Issues with sampling time and jitter in Annex 93A

Adam Healey
IEEE P802.3bj Task Force
May 2013

Part 1: Jitter (comment #157)

Treatment of jitter in COM Draft 2.0

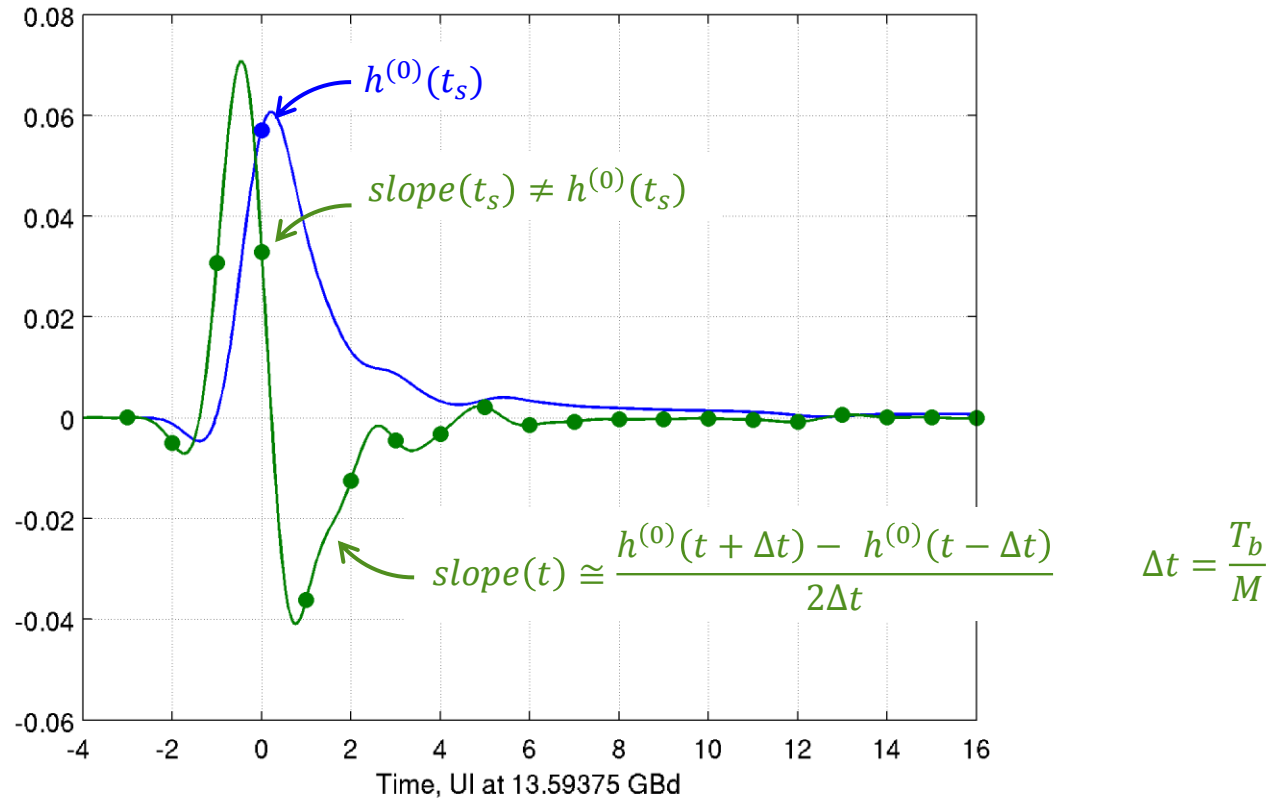
- (amplitude error, V) = (timing error, UI) x (slope, V/UI)
- Estimate the slope to be the amplitude of the pulse response at time t_s
- Assume the slope around pre- and post-cursor samples is negligible

Testing the assumptions

- The slope around t_s is not necessarily the signal amplitude
- The slope around pre- and post-cursor samples is not negligible
- Predictions of the impact of jitter may not be accurate

A better, but still simple, estimate

- Calculate the slope of the pulse response

- Sample the slope at 1 UI intervals around t_s

- Estimate the variance of the amplitude error due to timing error

- In Equation (93A-27) replace $(A_s \sigma_{RJ})^2$ term in denominator with σ_J^2

Current method versus proposal

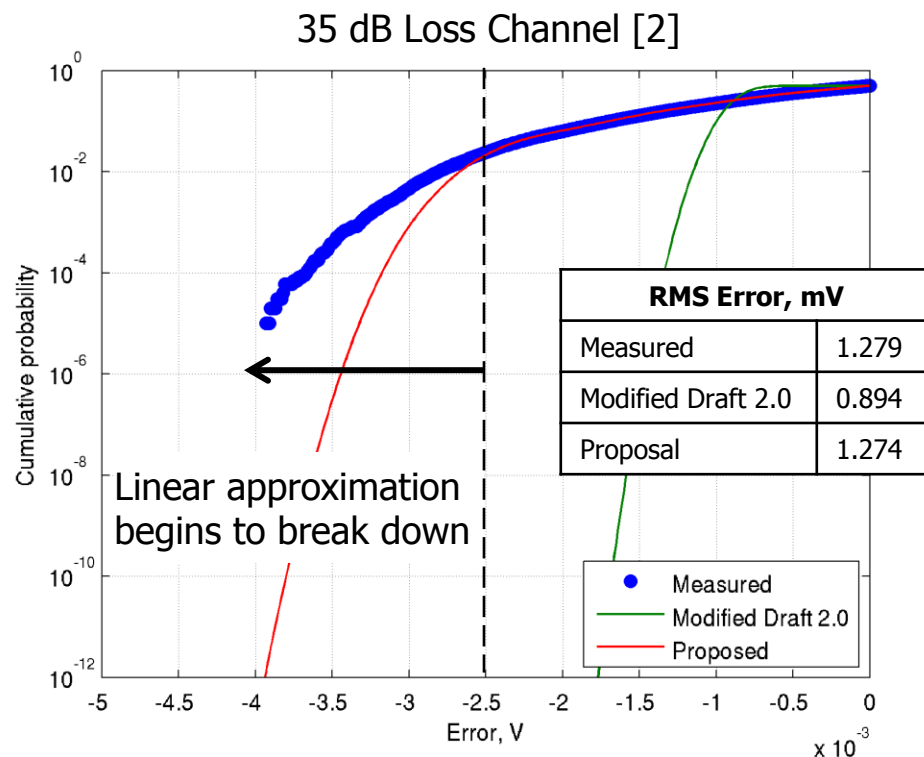
- Measured data based on time-step simulation of 100,000 random symbols
- Proposal in better agreement with empirical distribution
- Proposal is still an estimate – more terms are required to correctly model larger time offsets

IBM Experimental Backplane Test Fixture: 35 dB Loss Channel, 100GBASE-KR4

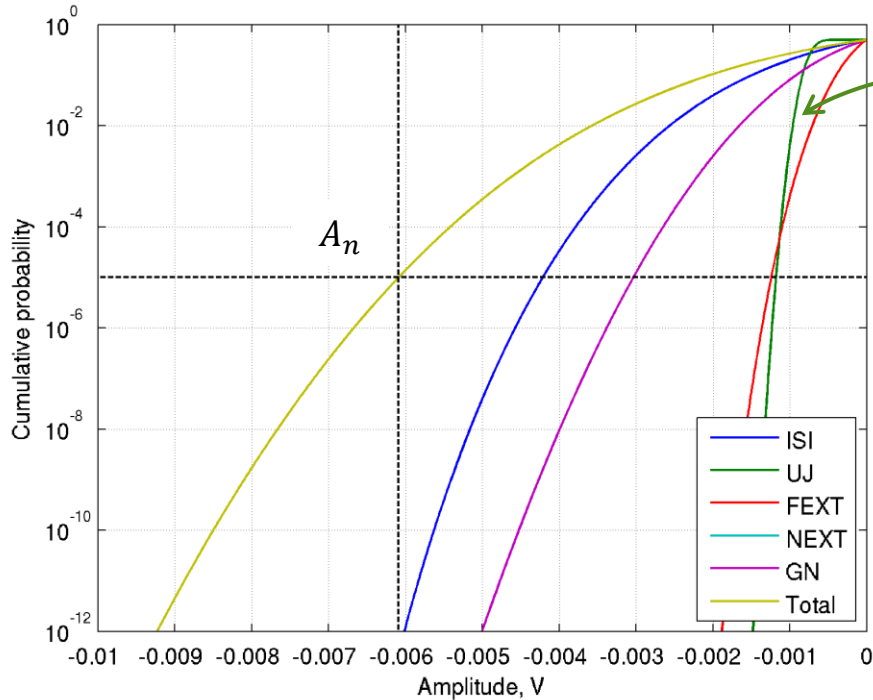
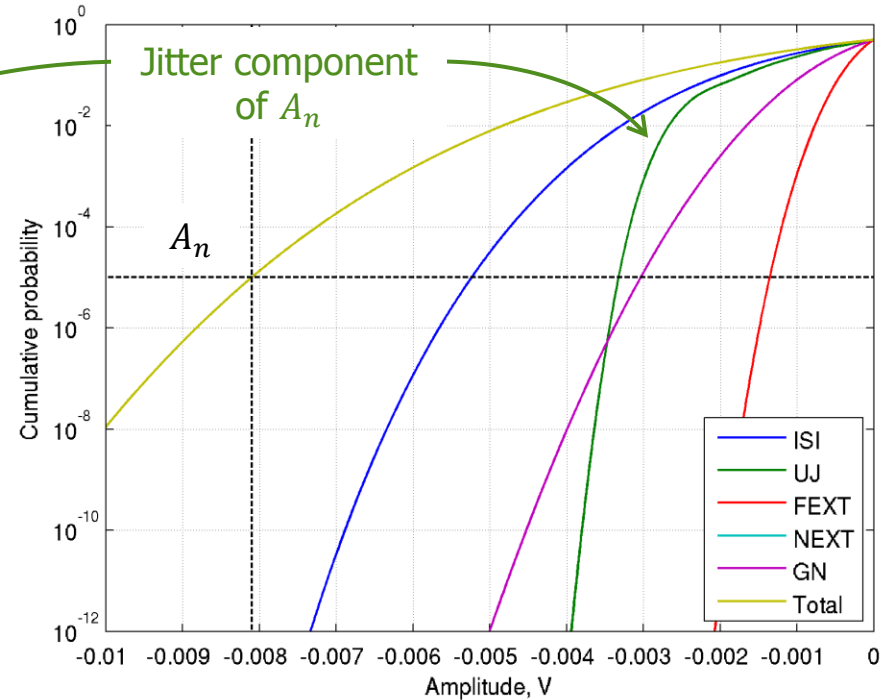
- Proposed estimate of the error variance influences equalizer configuration
- Proposed estimate of the error distribution influences the COM value

Measured ATCA Backplane Channels: Longest Link, 100GBASE-KP4

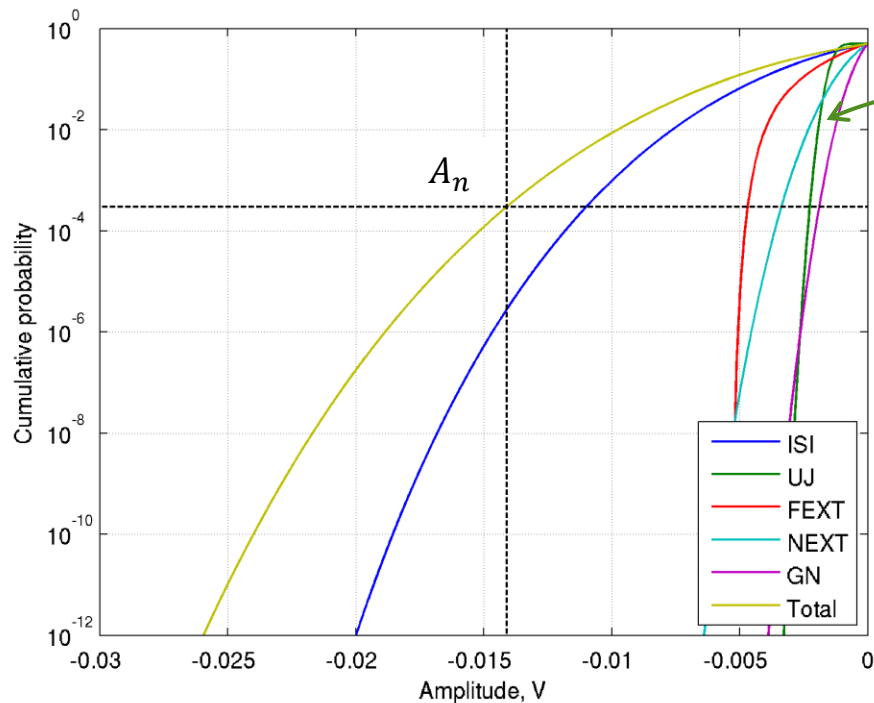
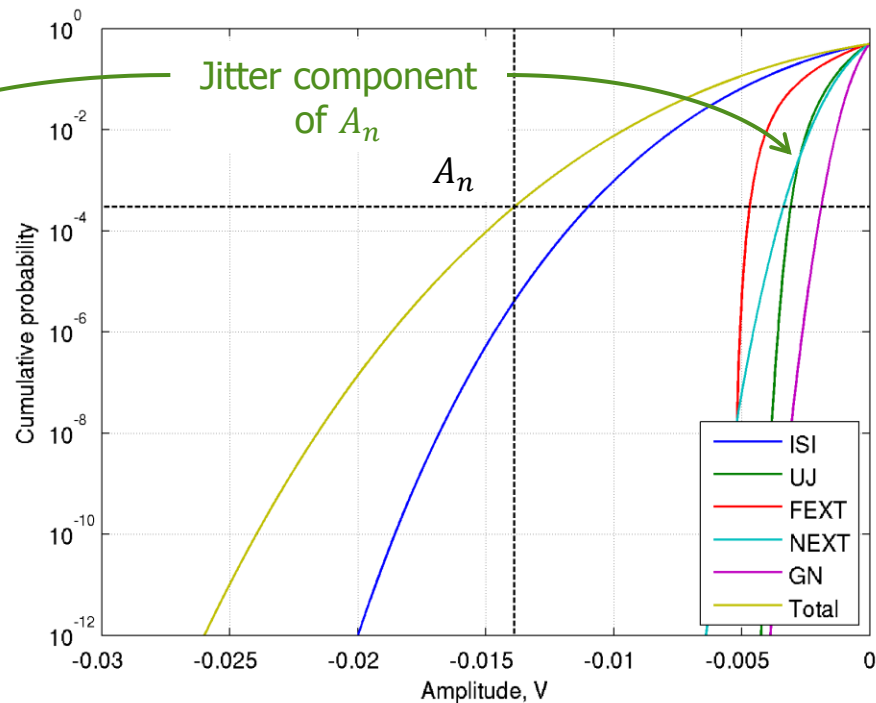
- A_{DD} and σ_{RJ} significantly reduced relative to 100GBASE-KR4
- In these examples, COM is dominated by residual inter-symbol interference
- Impact of the proposal is muted by other impairments

Model comparison

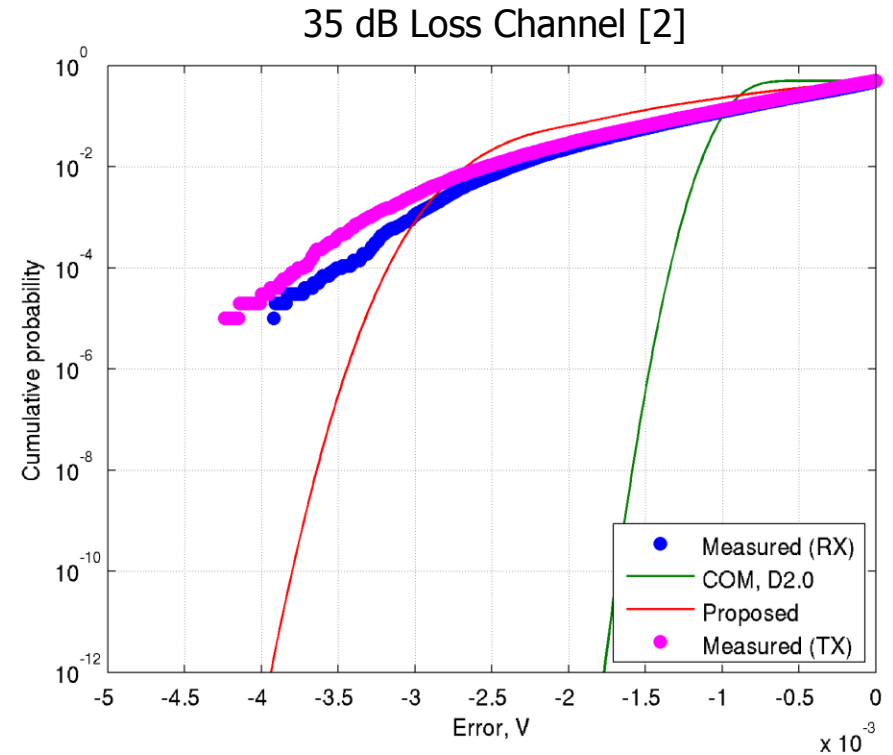
- Measured data based on time-step simulation of 100,000 random symbols
- Deterministic jitter for time-step simulation is sinusoidal with amplitude A_{DD} and period $500T_b$
- Proposal makes simplifying assumption and is not a precise representation
- But, it is less optimistic than the current treatment
